MODIFICATION BULLETIN NO. C series-001

Model		CSO, CFO, CS1, CRO (USA only)				Date of Modification	
Modified Article		Eraser				* Execution Date	
Reason for Modification		<input type="checkbox"/> Parts catalog correction <input type="checkbox"/> To meet standards () <input type="checkbox"/> To facilitate assembly <input type="checkbox"/> Vender change <input type="checkbox"/> Part standardization <input type="checkbox"/> To improve reliability <input checked="" type="checkbox"/> Other				H081-22: From Feb. production~ H081-23: R7340100001~ H081-24: R7440100001~ H081-26: From Feb. production~ H081-27: From Feb. production~ H082-20: R8040100001~ H082-21: From Feb. production~ H082-22: From Feb. production~ H082-23: L754010921~ H510-20: R884010001~ H510-21: 6404010236~ H510-22: L424010749~ H510-27: 0840100001~ H511-20: R8740100001~ H511-21: 6354010211~ H511-22: L4640104807~ H511-27: 0940100001~	
		Countermeasure for black bands/lines on the received copy. (Refer to the RTB No. GENERAL-004)

MODIFICATION BULLETIN NO. C Series-061ISSUED ON Dec. 15, 1994

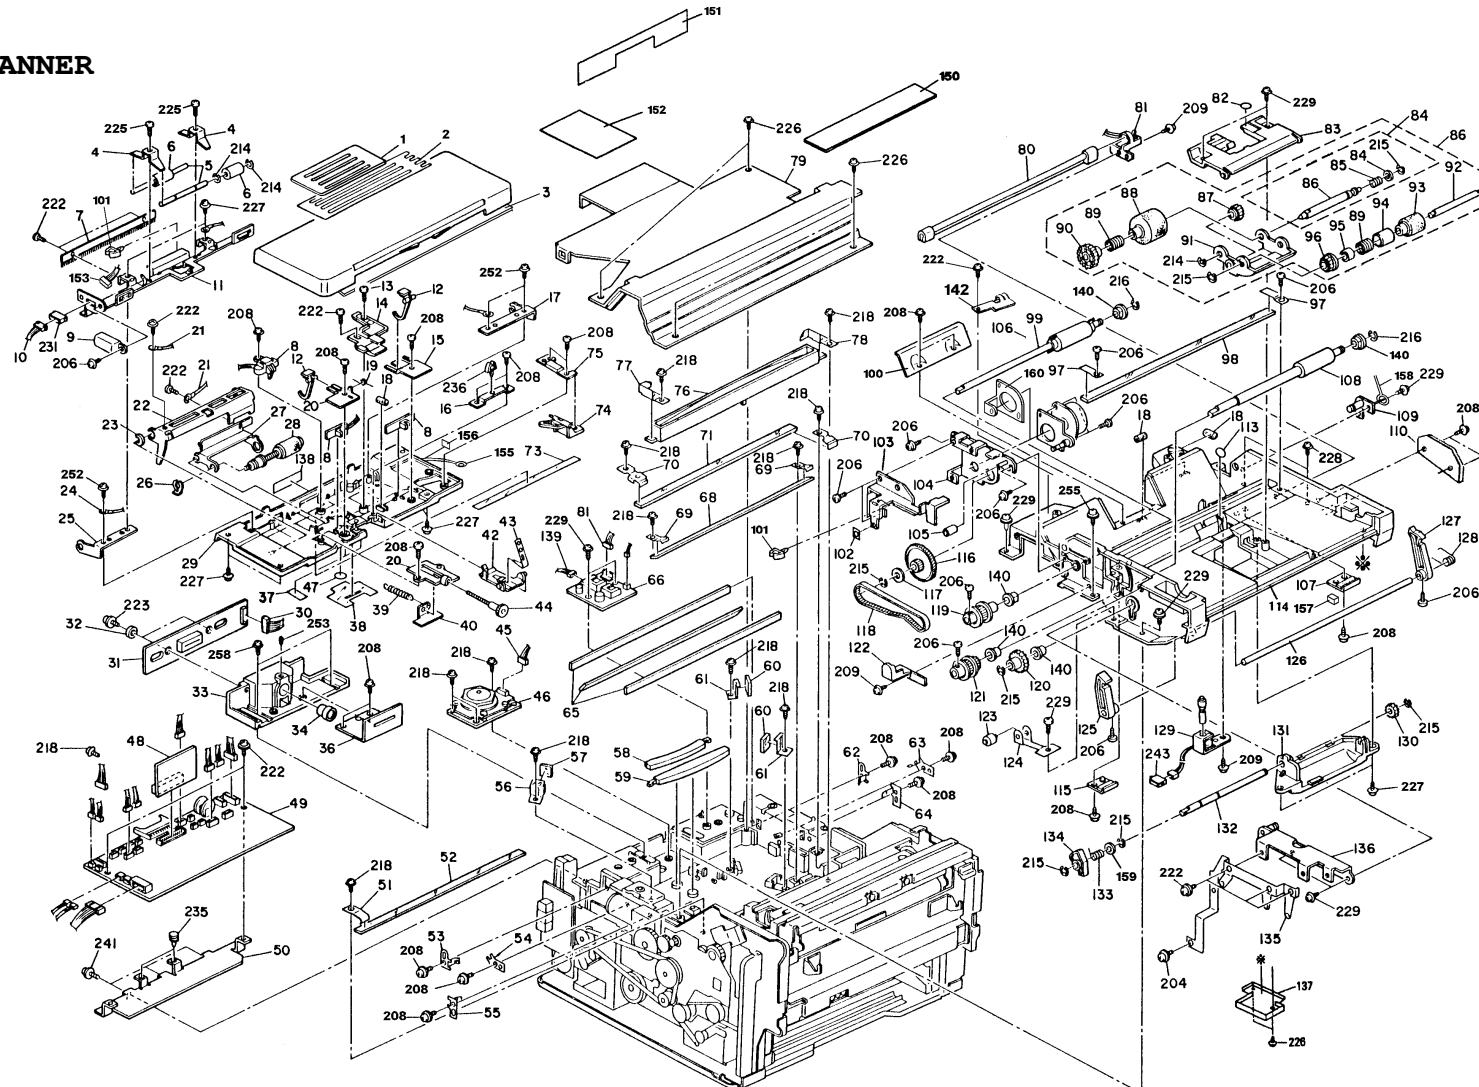
Model	CGO (H513-20, 23, 53)	Date of Modification
Modified Article	PCB - Op-port	Execution Date
Reason for Modification	<input checked="" type="checkbox"/> Parts catalog correction <input type="checkbox"/> Vender change <input type="checkbox"/> To meet standards () <input type="checkbox"/> Part standardization <input type="checkbox"/> To facilitate assembly <input type="checkbox"/> To improve reliability <input type="checkbox"/> Other

Old Part No.	New Part No.	Description	Q'ty Used Old Æ New	Interchange- ability	Remarks	Parts Catalog	
						Index No.	Page
	H5136012	PCB - Op-port				3	1-5
